SUBJECT: Notice of Completion of Corrective Actions Taken in Response to Generic Letter (GL) 2004-02 and Response to Request for Additional Information (RAI) for Fort Calhoun Station (FCS) Unit No 1

Omaha Public Power District's Response to
Request For Additional Information

Supplemental Response To Generic Letter (GL) 2004-02

Figure 1 – Flow streamlines in the containment pool illustrated by releasing massless particles from Compartments A and B (Case 6, Break B)

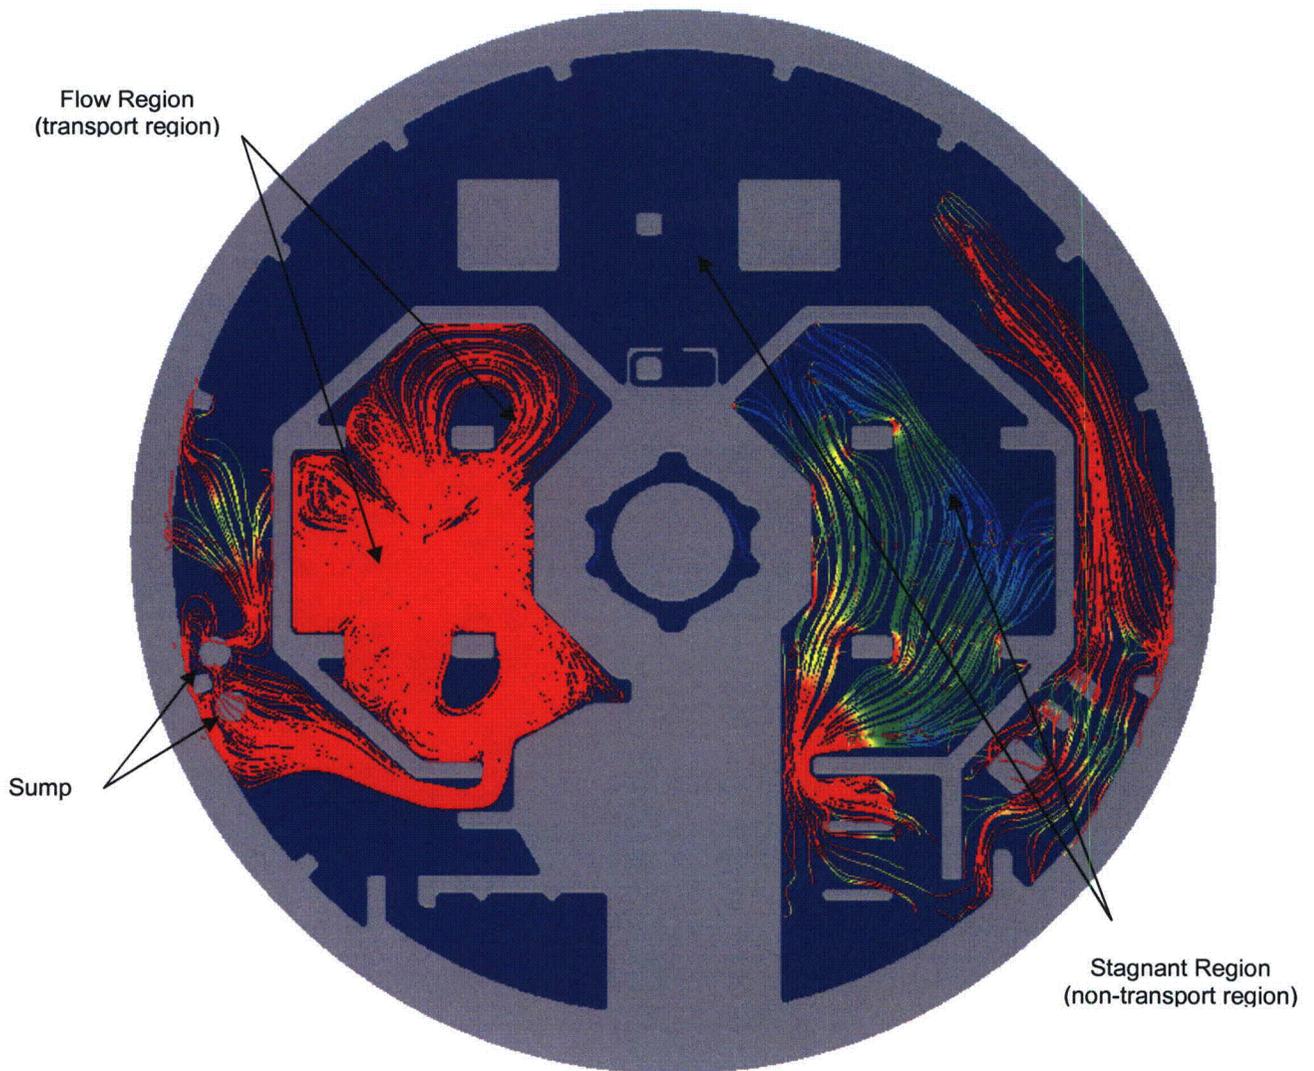
7. **Given all the uncertainties involved with condensation wash down over a 30-day period and the distribution of debris in containment following blowdown, please provide the technical basis for the assumption of 5% wash down transport for fibrous debris and coatings from upper containment (and potentially for other fine debris such as calcium silicate particulate). NUREG/CR-6762 Vols. 1 and 4 consider 5% wash down a favorable estimate for minimizing transport and consider 10% an unfavorable estimate. The estimated wash down fractions used in NUREG/CR-6762 as well as Appendix VI to the staff's SE were ultimately based on NUREG/CR-6369, which indicates that directly applicable experimental data for condensate (from steam in the containment atmosphere) drainage transport is non-existent and that the wash down fractions therein are essentially based on engineering judgment. This suggests that use of the 10% estimate might be more appropriate.**

The debris generation calculation determined that the largest debris load is created by a break in A SG bay. The CFD model shows that for such a break, the only active transport path is from the A SG, while the B SG cubicle is a stagnant area. (See Figure 9 on page 43 of the supplemental response LIC-08-0021). Any wash down due to condensation from the CACFS will increase the debris in or around the B SG cubicle, but will not be entrained in the flow path from the A SG break. A break in B SG (See Figure 1 below) results in a smaller debris load and an increase in the wash down from 5%, as assumed in the transport calculation, to 10%, as suggested by the RAI, is still bounded by the debris load from A SG case for which the strainer was tested.

In addition, as stated on page 62 (last paragraph) of the supplemental response (LIC-08-0021), the testing modeled the “B” sump strainer because of the higher flow rates that could be associated with this strainer (two HPSI pumps), while conservatively using the higher debris loads associated with the “A” strainer. Based on these assessments, a condensation wash down to the pool of 5% is considered conservative.

**Figure 4-1 Fort Calhoun Replacement Suction Strainer Assembly
Finite Element Model**

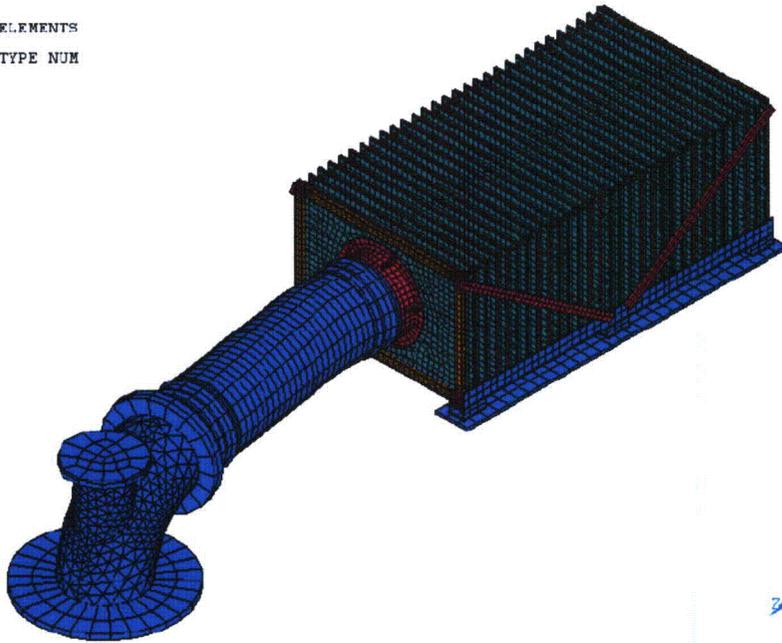
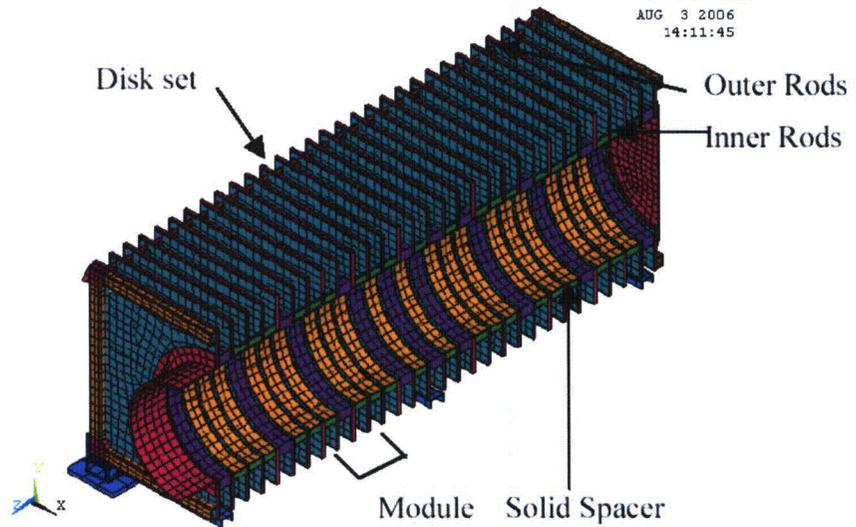
- 28. The Revised Content Guide for GL 2004-02 requests a summary of the design inputs, loads, and load combinations utilized for the sump strainer structural analysis. The submittal which was provided contains a pointer or reference to a GE calculation which contains this information, but none of the actual information was summarized or provided. Please provide this summary information.**

The structural analysis utilizes the suction strainer assembly finite element model shown in Figure 4-1. The strainer assembly is modeled with solid elements (ANSYS Element Types 45 and 190). The strainer disks and spacer rings are composed of perforated plates with 1/16" diameter holes on a triangular pitch. The spacer rings are situated between the disks at the inner circle. The holes were not included in the integral strainer analysis model because of the model size limitation. Instead, the perforated plates are modeled with equivalent solid plates with modified material properties.

Document Title 10M-SBLOCA-LDFG-Verified.xls 12/11/07 12:50 pm
 contained in 10M-SBLOCA-LDFG-Verified

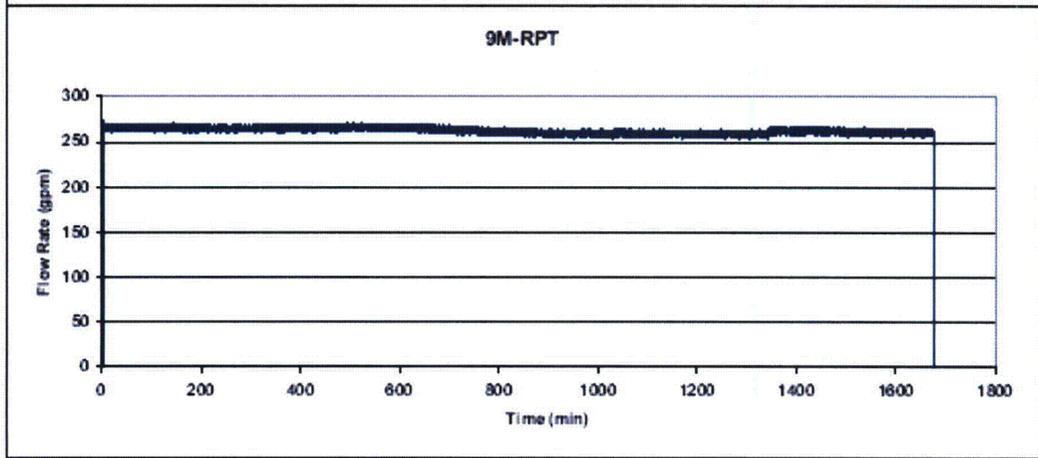
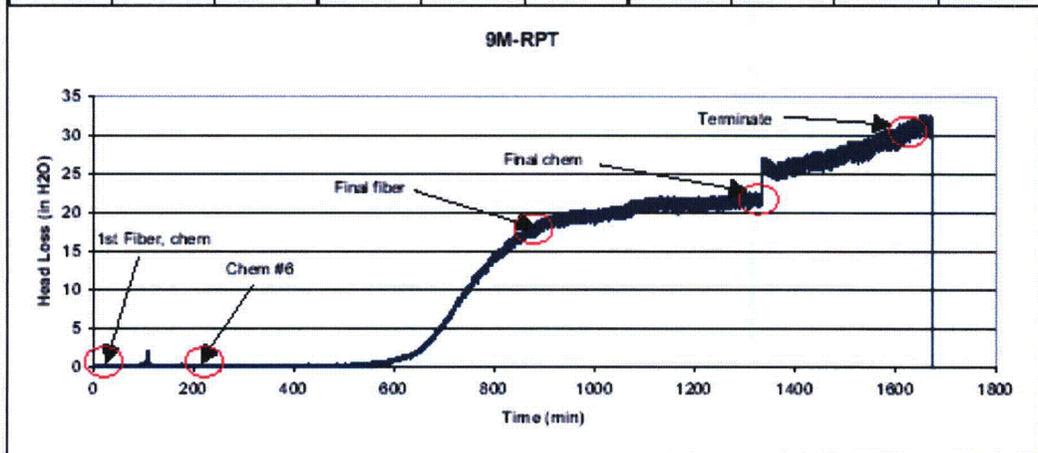
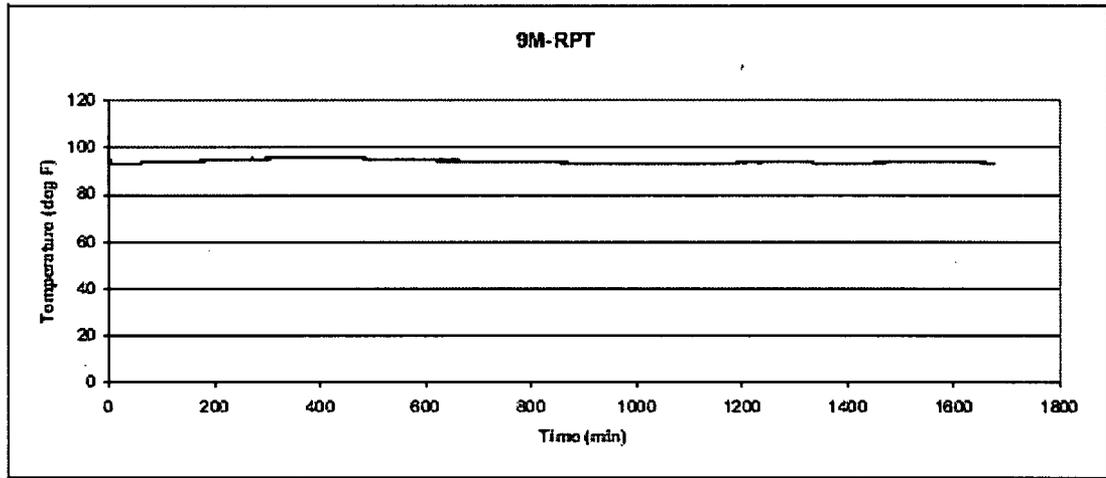
- 22. Please provide the test termination criteria and the methodology by which the final head loss values were extrapolated to the emergency core cooling system (ECCS) mission time or to some predicted steady-state value. Please include enough test data that the extrapolation results can be confirmed.**

10M-SBLOCA-LDFG (non-design basis test) was terminated at approximately 5800 minutes for a total of $(5800/17) = 341$ turnovers; test 10M-SBLOCA-LDFG was terminated based on a stable head loss and well after the plant-representative 101 water turnovers were achieved (See graph provided in Enclosure, Attachment 1). Banding and jacketing of insulation have changed the plant debris loads such that 10M-SBLOCA-LDFG is no longer a representative case. 10M-SBLOCA-LDFG is not the design basis test and is presented for information only.
